Access Compliance Report Public Rights-of-Way (Curb Ramps)

Main Street: NEWPORT_AVE Cross Street: LA_LIMONAR_RD Location: SE

ADA ID: RPRK211013135509 Ramp Type: Type 1 - Perpendicular Diagonal Initial Pass/Fail: Pass Overall Compliance: No Severity Score: 10

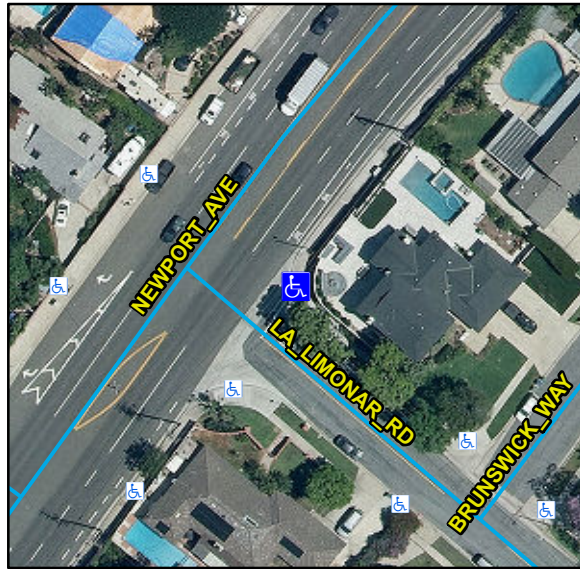
R304.2.2, R304.2.1, R304.2.2-Perp, R304.3.2-Para, R304.5.3, STD 1115

Remove & Replace Curb Ramp With Two New Directional Ramps or Equivalent.
